Subject: 2014 Best Management Practices (BMP) Plan Addendum to the October 2010 Santa Susana Site Outfalls 008/009 Watersheds BMP Plan, Santa Susana Field Laboratory, Ventura County, CA (Order No. R4-2010-0090; NPDES No. CA0001309, CI No. 6027)

**2014 BMP PLAN ADDENDUM**

**SANTA SUSANA SITE**

**The Santa Susana Site Surface Water Expert Panel**

**Figure 2: ELV Channel Recommendation 2**

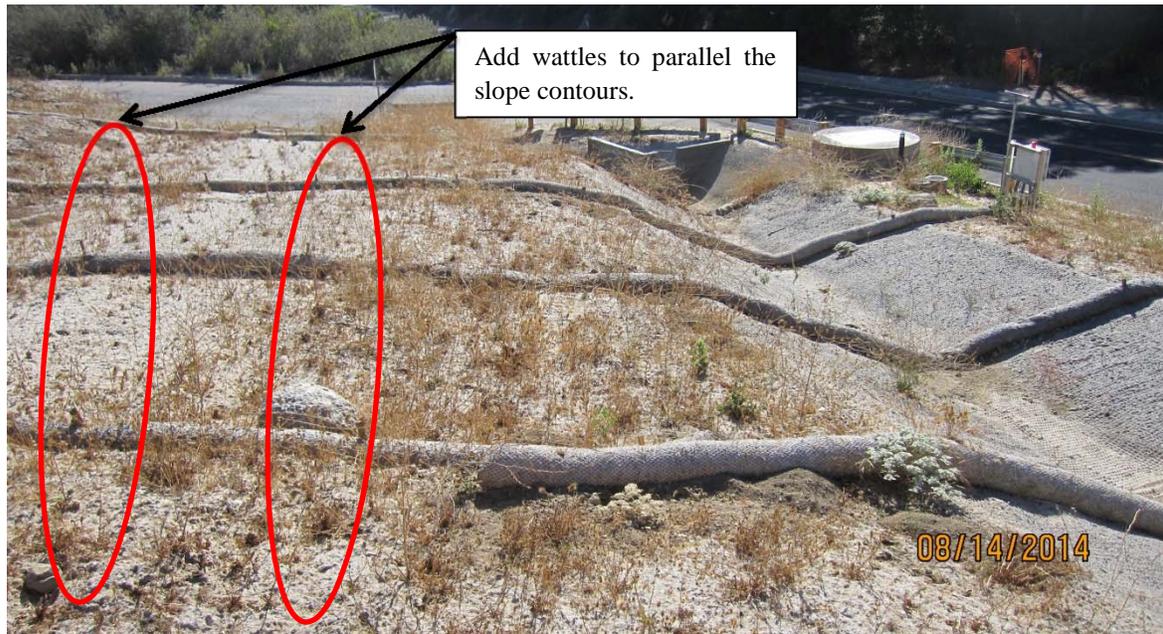
Recommended actions for the ELV area follow NASA's completion of the treatment system installed in November of 2013. During a field meeting on August 14, 2014 amongst NASA and the Panel, recommendations were made regarding modifications to the ELV channel to further improve the existing erosion controls. Recommendations included: adding sandbags along the edge of the ELV channel riprap [Recommendation 1] (Figure 1), extending the matting over the side of the ELV channel especially where rodent holes were observed, and adding pass-through bags parallel to the ELV channel to hold matting down but allow runoff to enter the channel [Recommendation 2] (Figure 2). In addition, the Panel recommends adding wattles to parallel the slope contours along the hillside north of the ELV channel to slow down the hillside runoff before

entering the channel [Recommendation 3] (Figure 3). It is also important to note that new operational procedures at the Helipad are expected to reduce flows along Helipad road into the ELV channel sump (as compared to the monitored 2013-2014 event), thus improving the ELV treatment capacity.

**Figure A1: ELV/CM-1 BMP Recommendations**

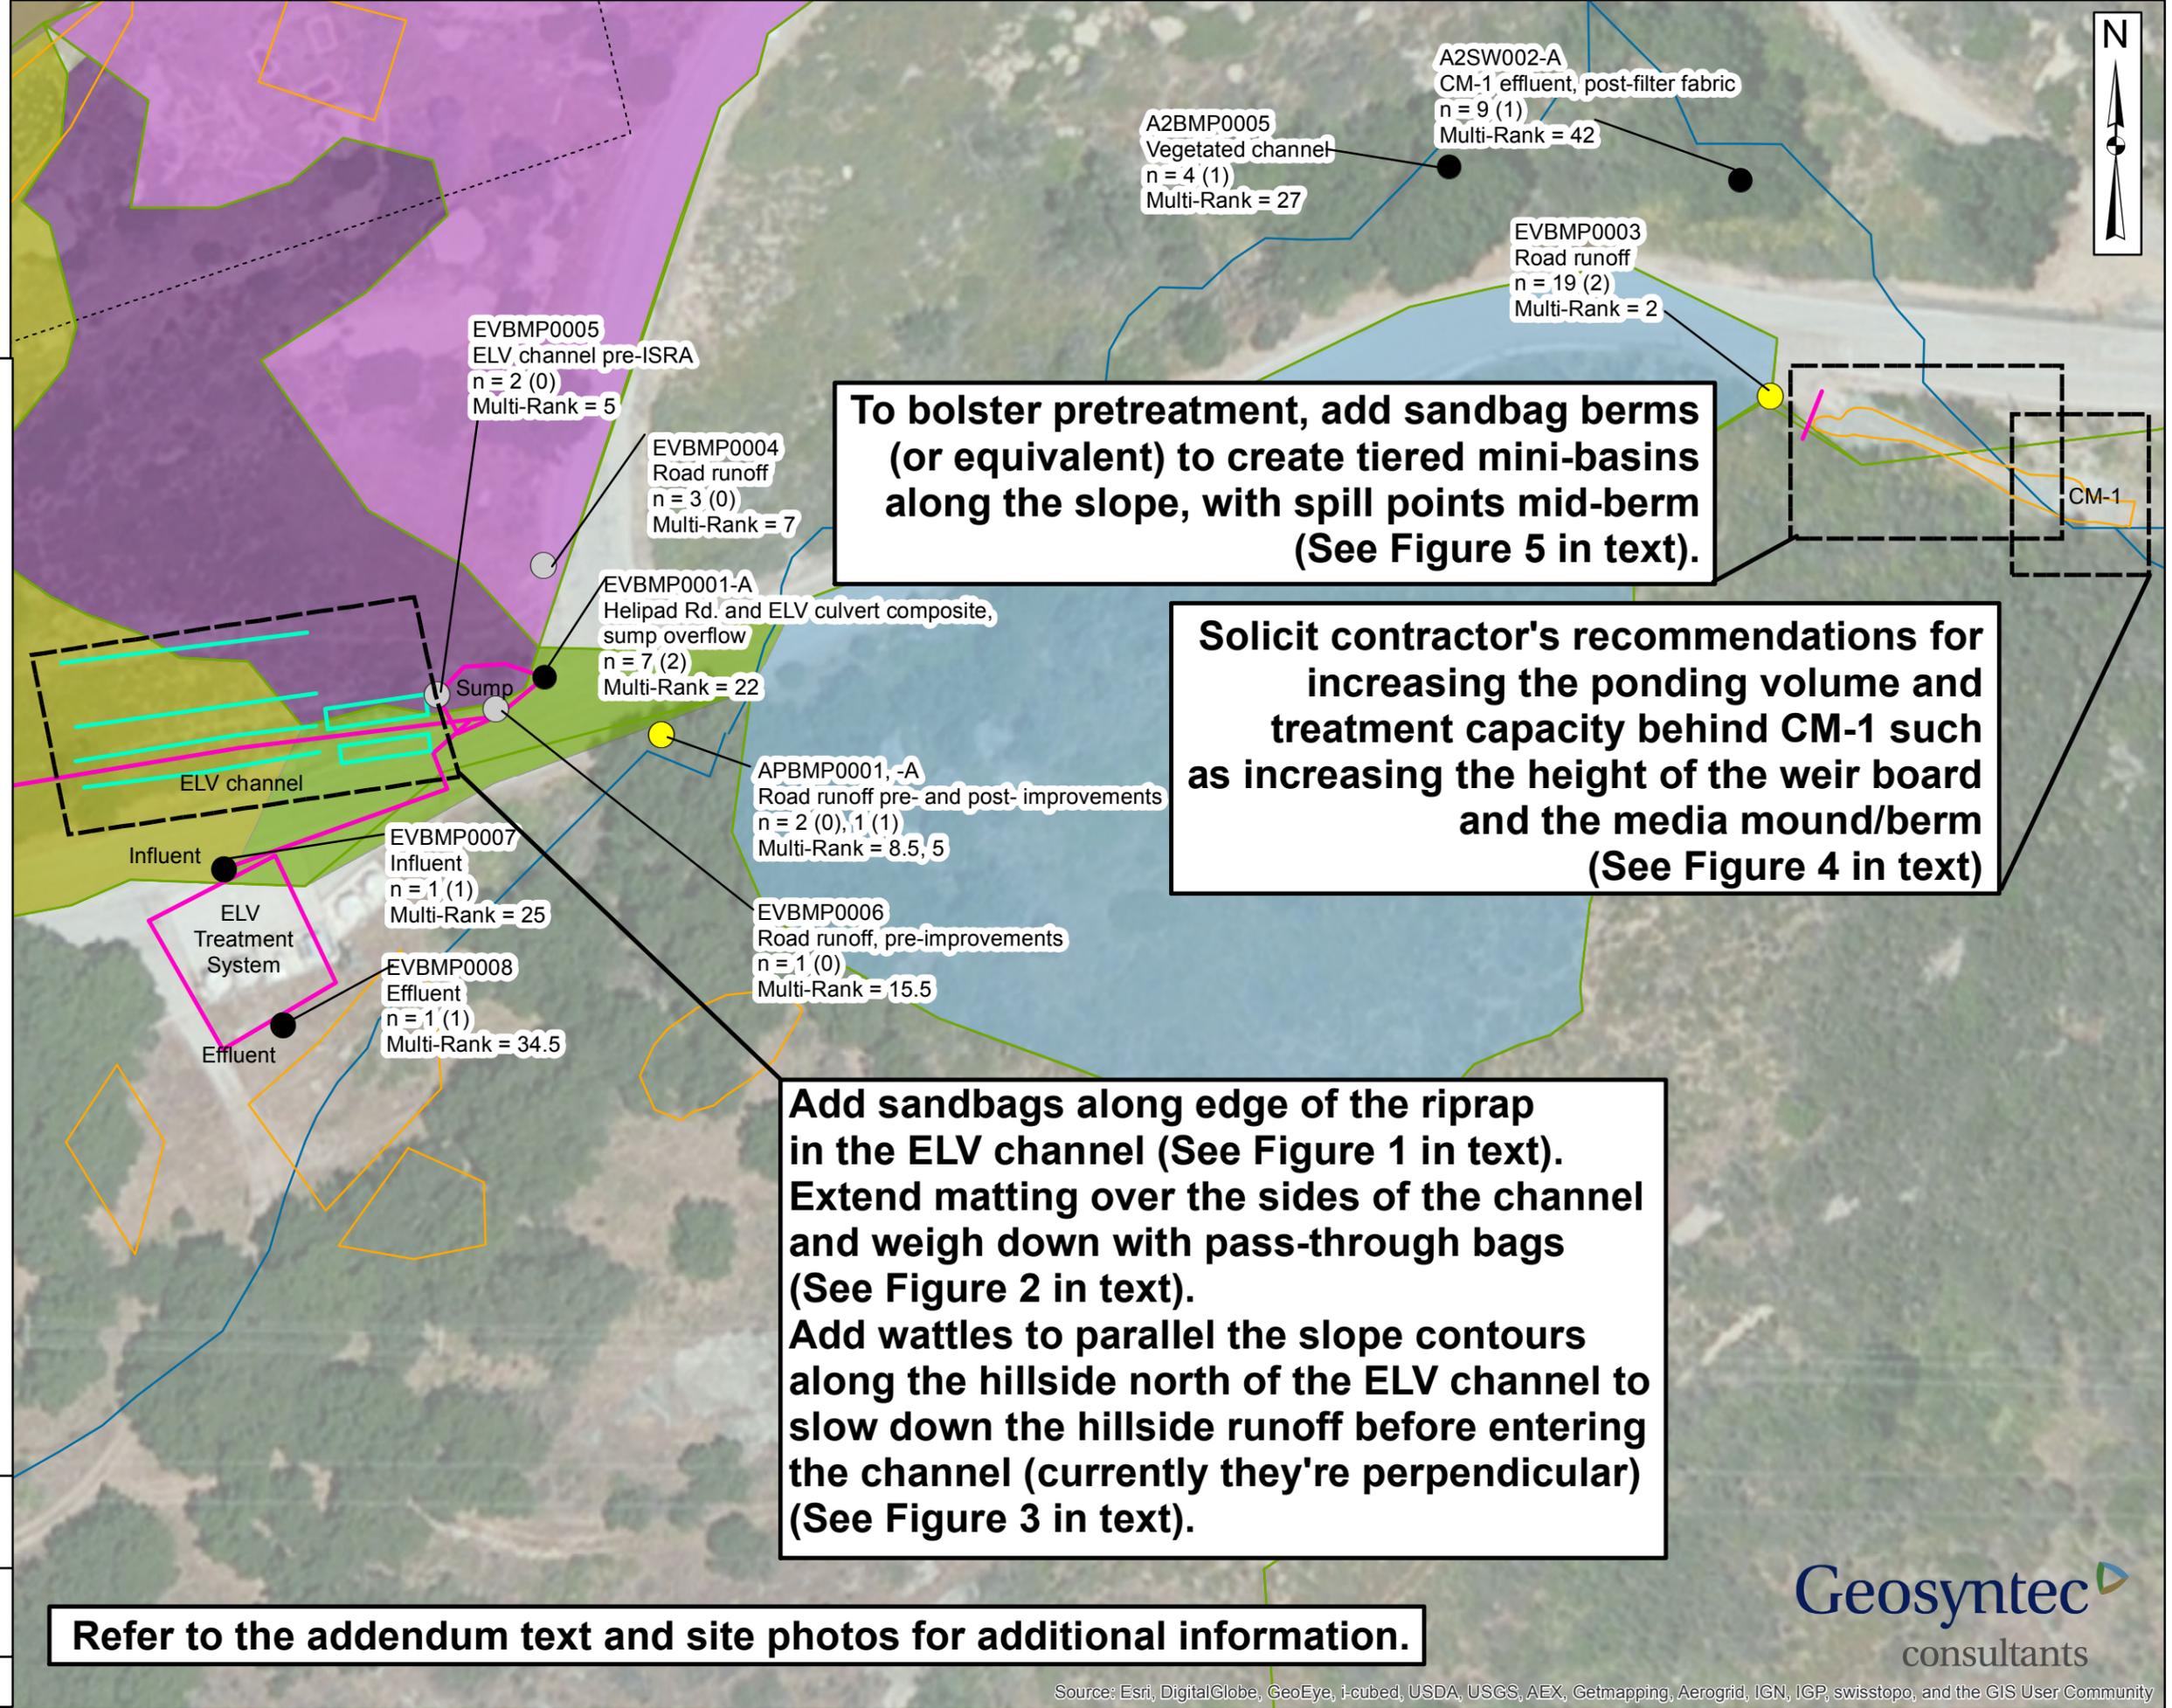
**To bolster pretreatment, add sandbag berms (or equivalent) to create tiered mini-basins along the slope, with spill points mid-berm (See Figure 5 in text).**

**Solicit contractor's recommendations for increasing the ponding volume and treatment capacity behind CM-1 such as increasing the height of the weir board and the media mound/berm (See Figure 4 in text)**

**Add sandbags along edge of the riprap in the ELV channel (See Figure 1 in text). Extend matting over the sides of the channel and weigh down with pass-through bags (See Figure 2 in text). Add wattles to parallel the slope contours along the hillside north of the ELV channel to slow down the hillside runoff before entering the channel (currently they're perpendicular) (See Figure 3 in text).**

**Figure A2: Helipad BMP Recommendations**

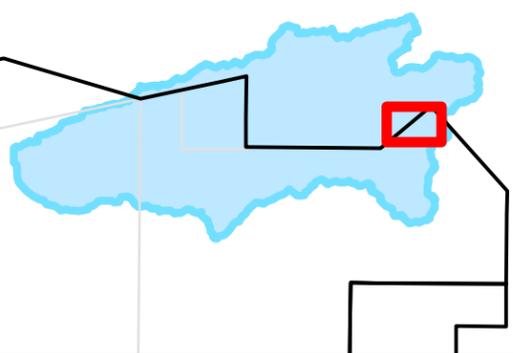
**Implement a robust SWPPP around the Helipad building demolition area. The SWPPP should include effective sediment controls, which may include but are not limited to sandbags around debris or soil stockpiles, dust controls, covering stockpiles during storms, and vacuum sweeping before storms.**

**Operate existing storm drain inlet plug along upper Helipad Road as recommended during the August 2014 site visit (see Figure 6 in text).**

**Figure A3: B1  
 BMP Recommendations**

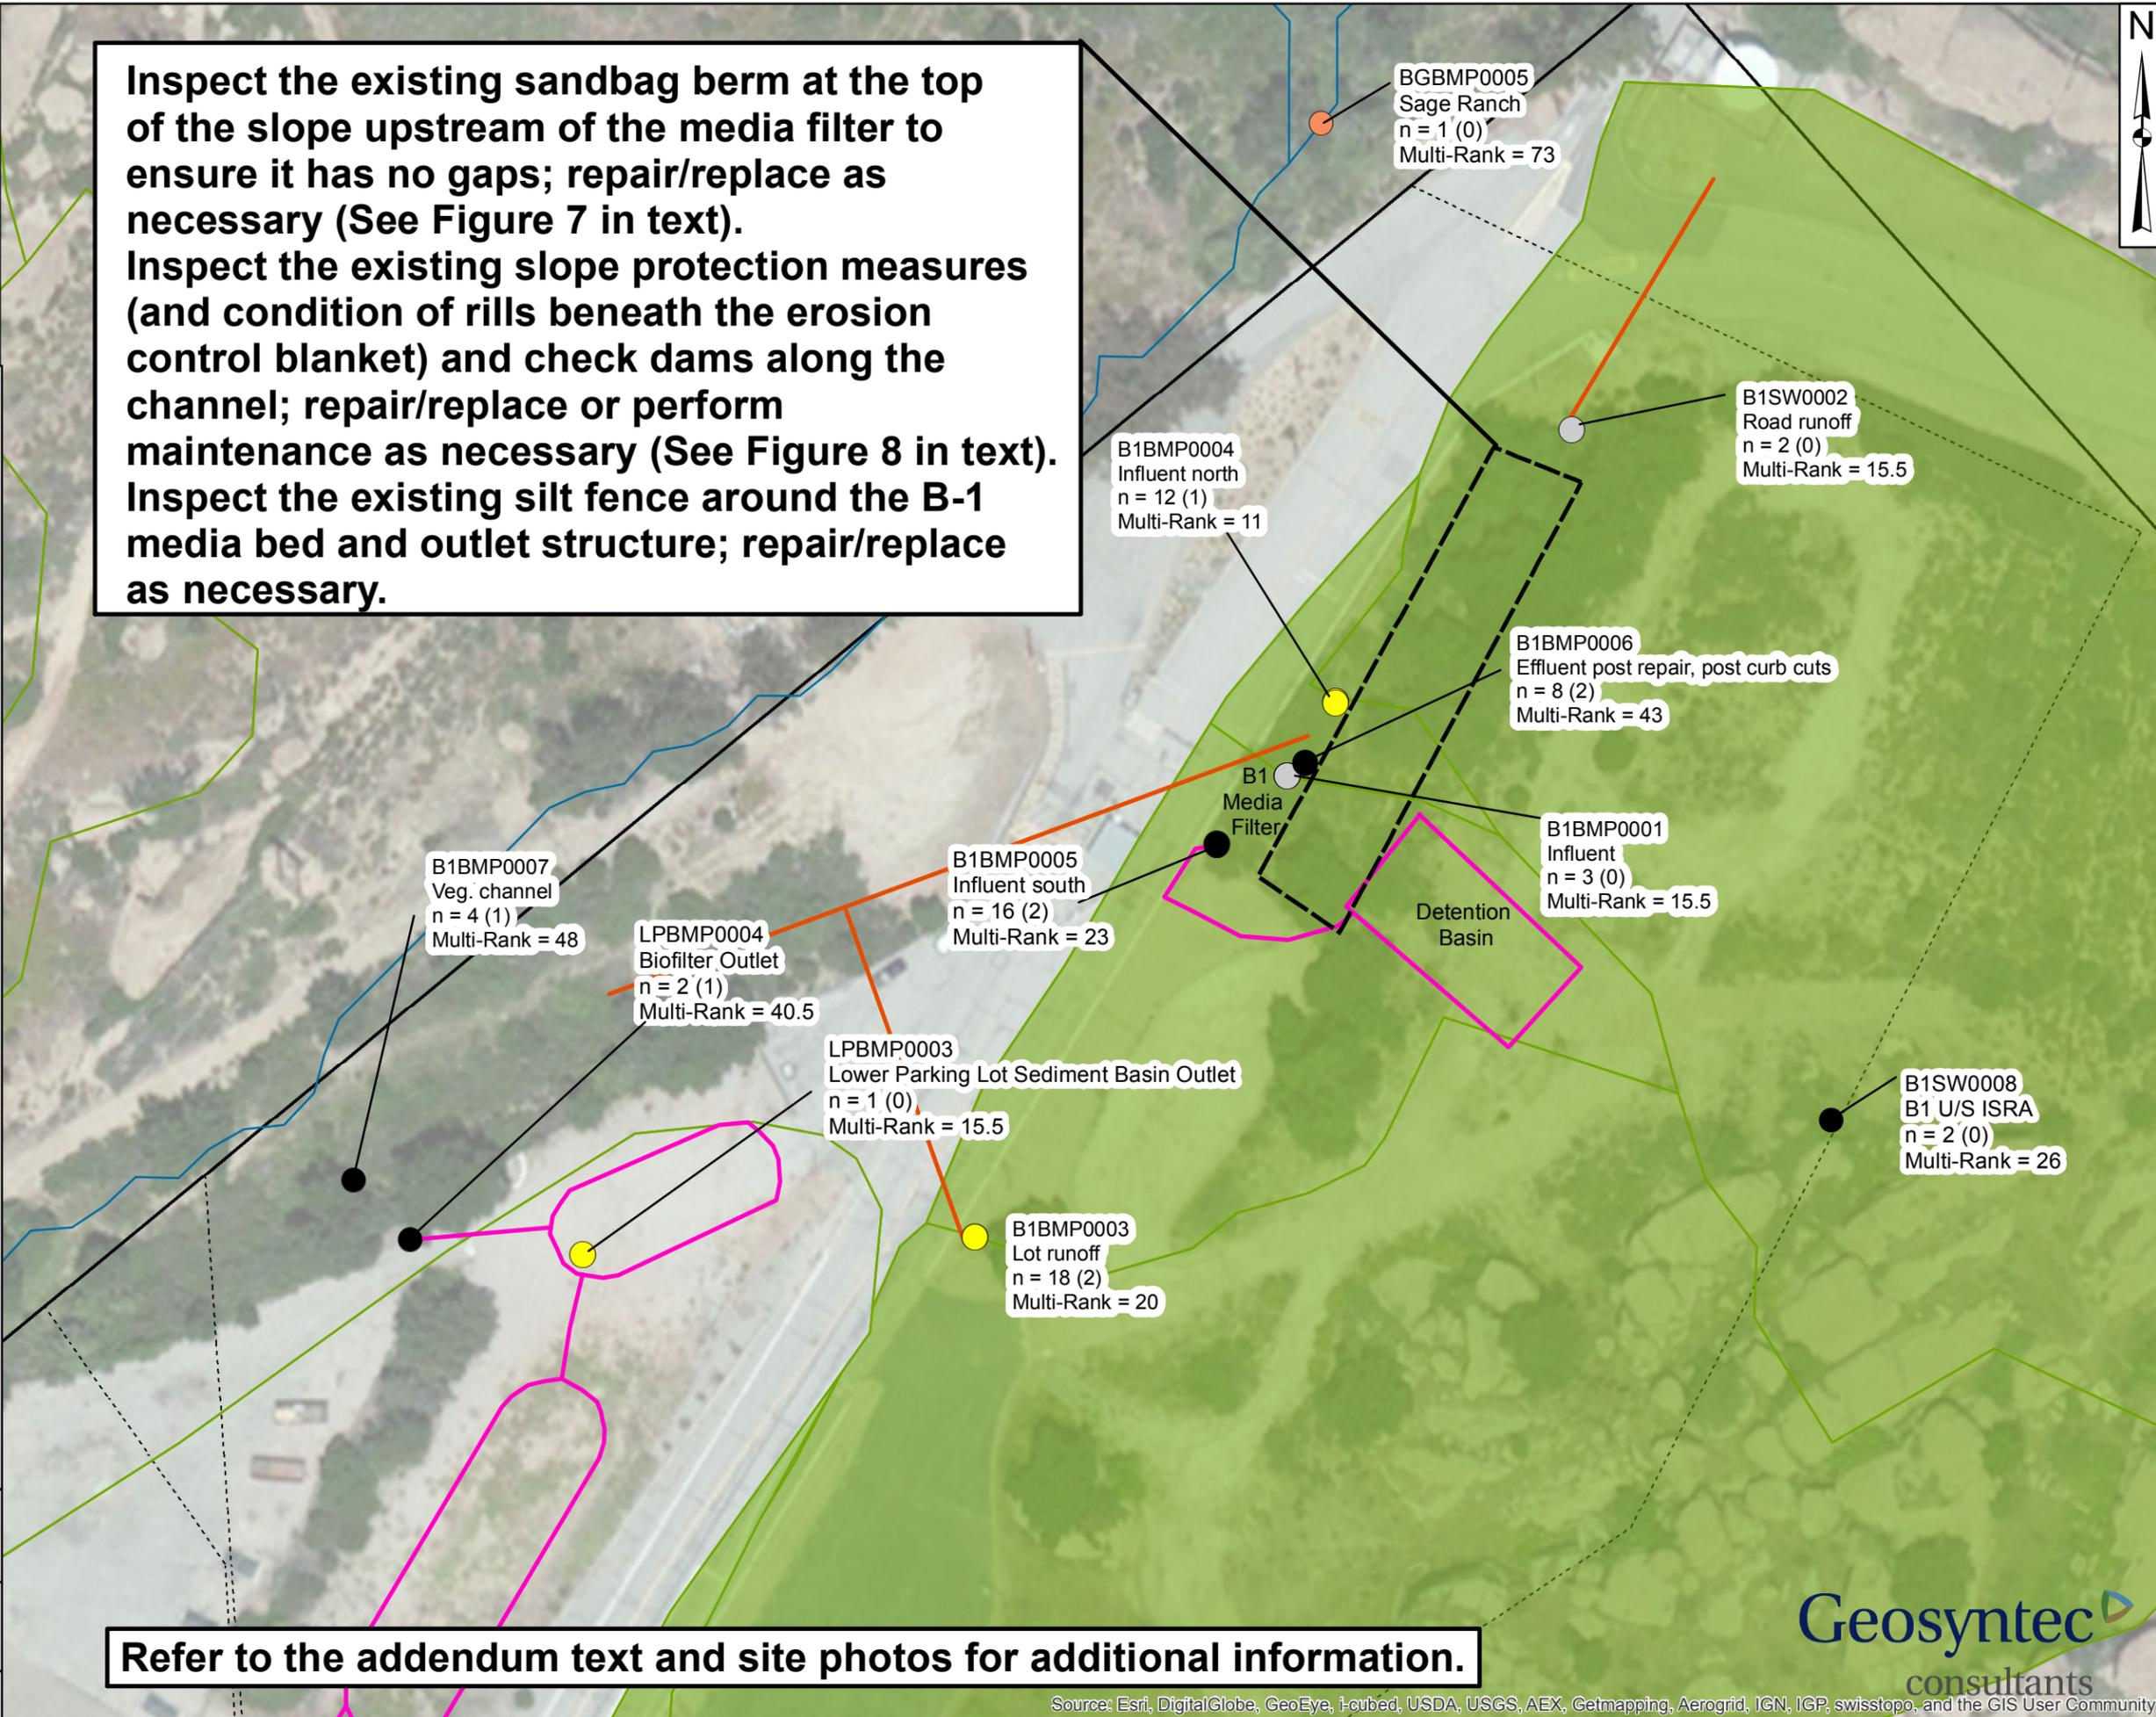
**Inspect the existing sandbag berm at the top of the slope upstream of the media filter to ensure it has no gaps; repair/replace as necessary (See Figure 7 in text).  
 Inspect the existing slope protection measures (and condition of rills beneath the erosion control blanket) and check dams along the channel; repair/replace or perform maintenance as necessary (See Figure 8 in text).  
 Inspect the existing silt fence around the B-1 media bed and outlet structure; repair/replace as necessary.**
